4040 ADDITION
4040 97TH AVE SE
MERCER ISLAND WA 98040

NO.	DATE	DESCRIPTION OF REVISIONS
	06/10/2024	PERMIT SET
	02/10/2025	CORRECTION #1

Correction response letter

4040 97th Ave SE, Mercer Island, WA 98040

1 SITE PLAN
1/8" = 1'-0"

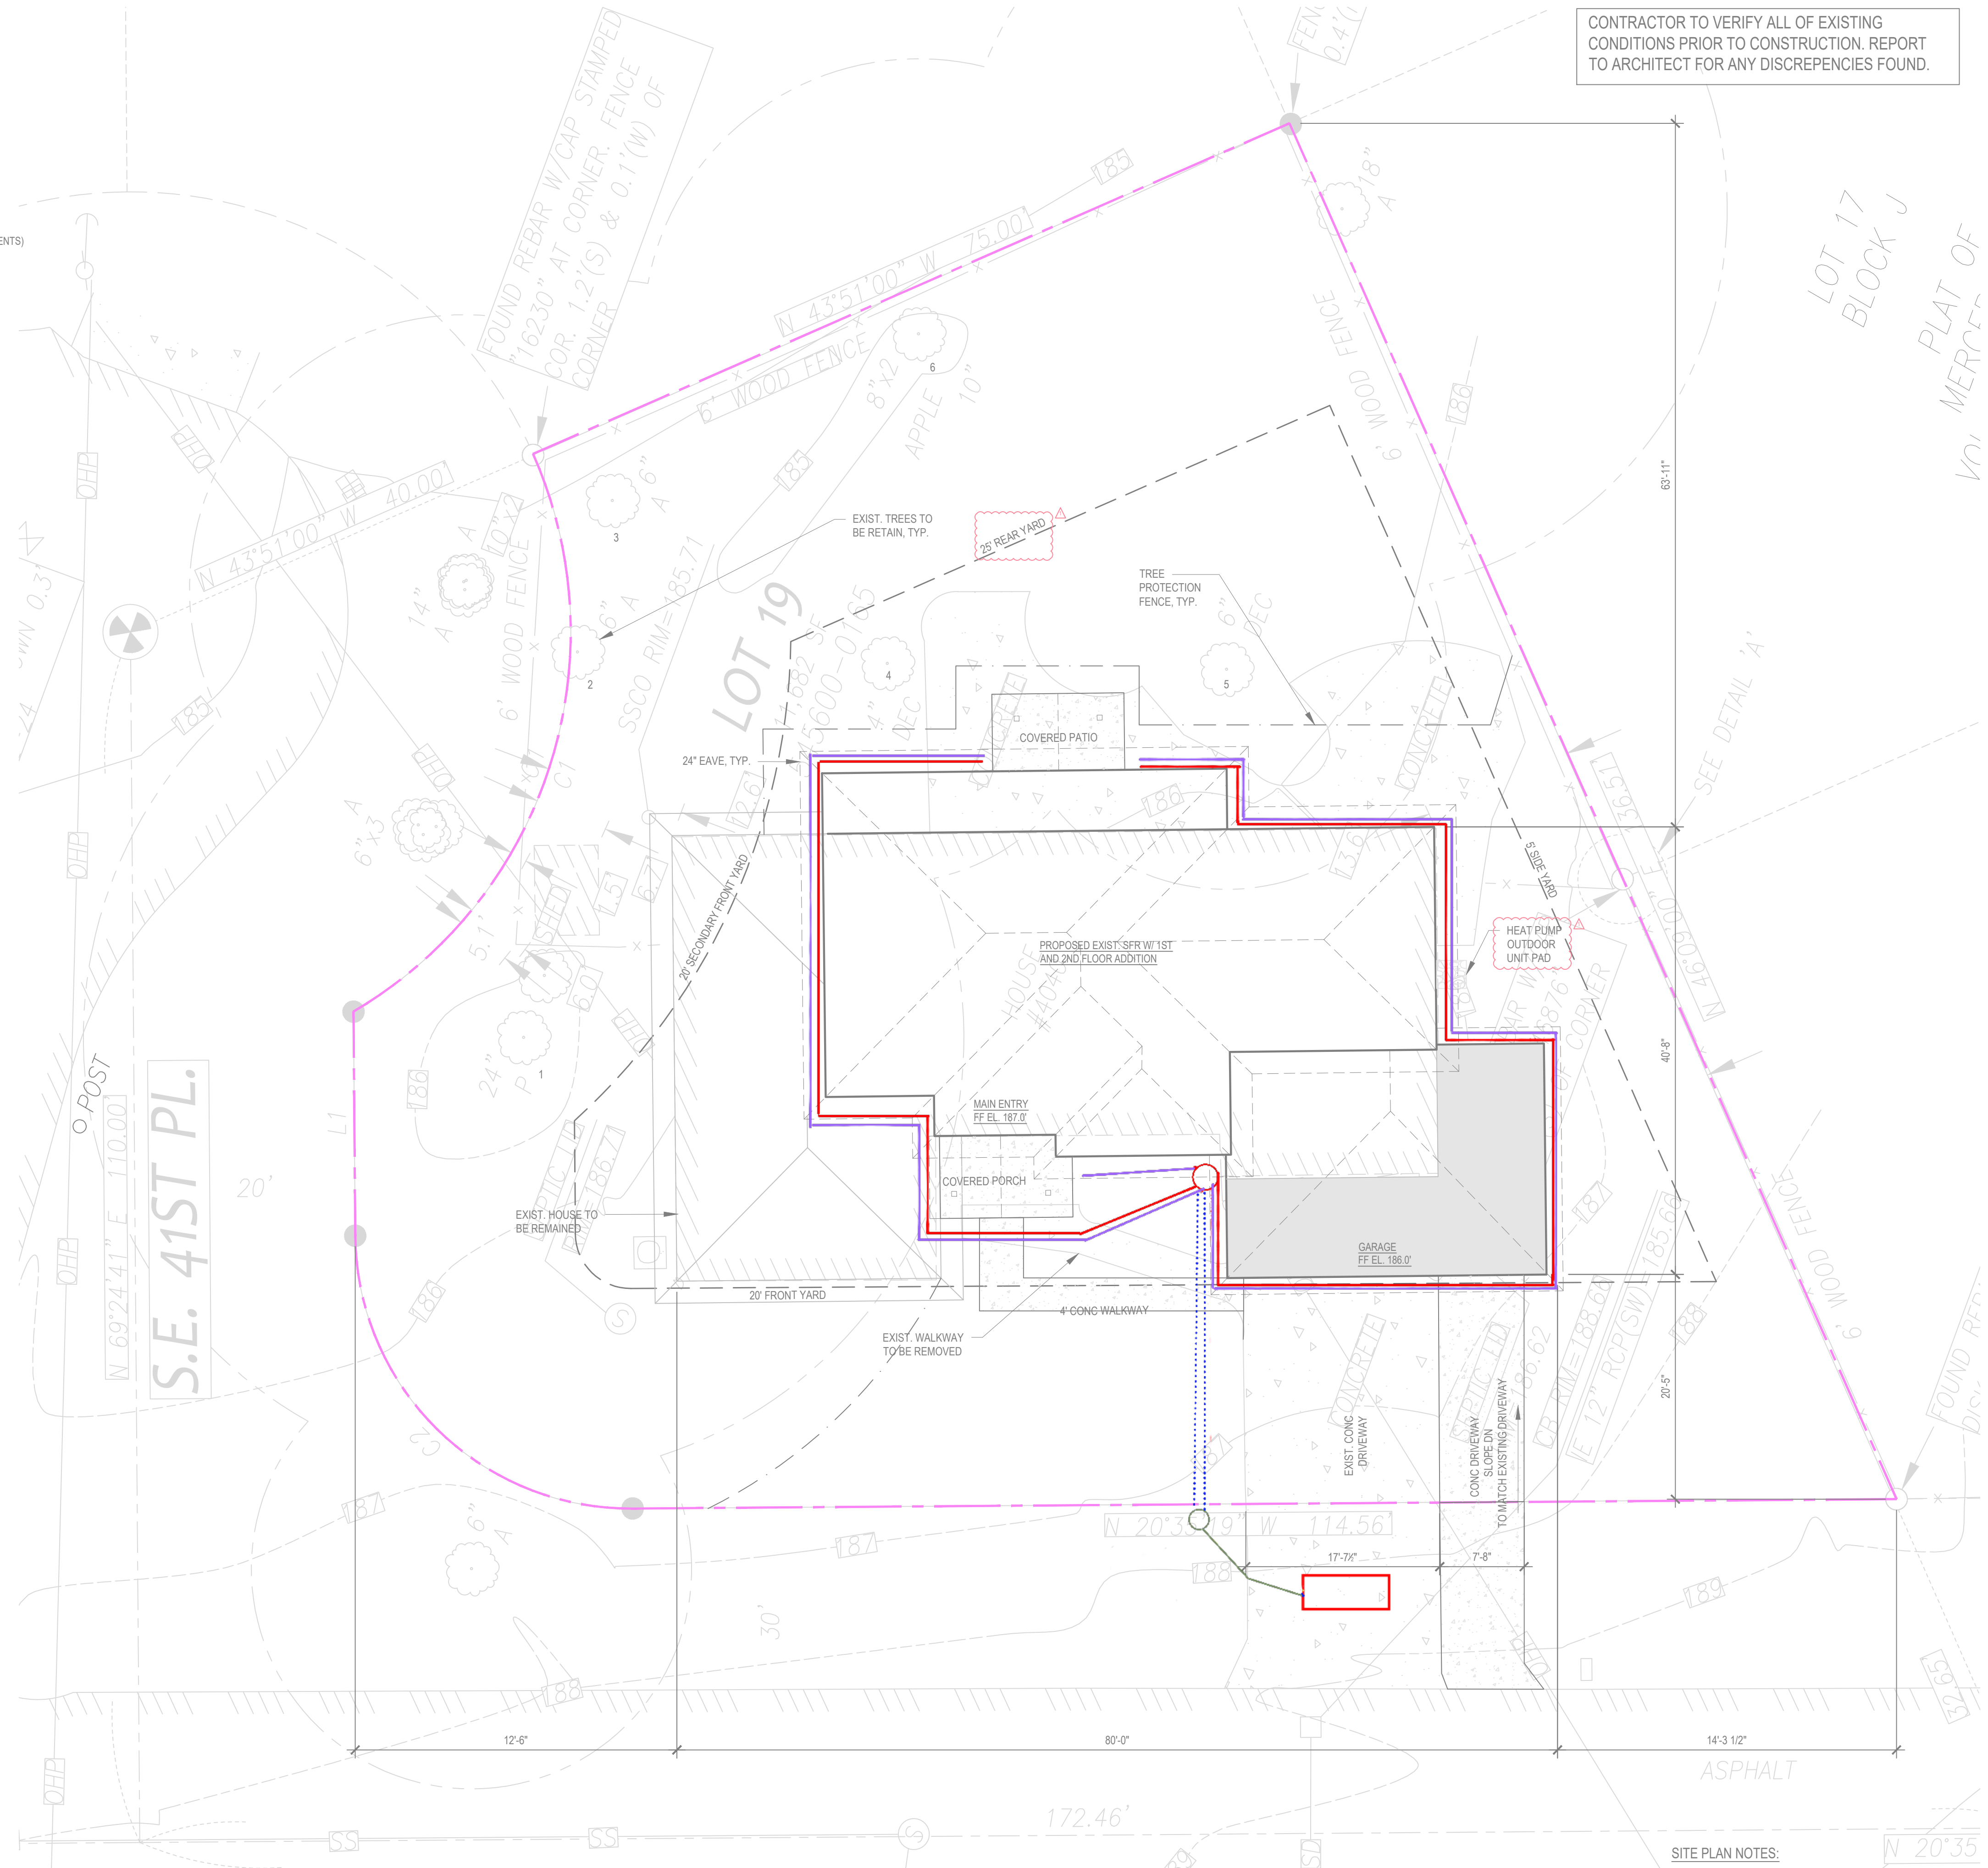
Drainage system drawing revise as follow:

1. Remove city's approval stamp
2. Change from (2" ABS pipe from catch basin to city storm drain) to (2" PVC pipe from catch basin to catch basin)
3. Add Catch basin (Green mark, near city storm drain, 24"x24"x30" depth)
4. Connect catch basin (green mark, near city storm drain) to city storm drain change with 6" Green PVC, 2% slope, connection of city of storm drain is 16" deeper than bottom of catch basin.

- City storm drain
- Catch basin 4'x3'x8' depth
- 4" perforated pipe for French drain
- 4" solid pipe for Downspout and gutter drainage
- 2" PVC pipe from catch basin to catch basin near city storm drain
- Catch basin 24" x 24" x 30" depth
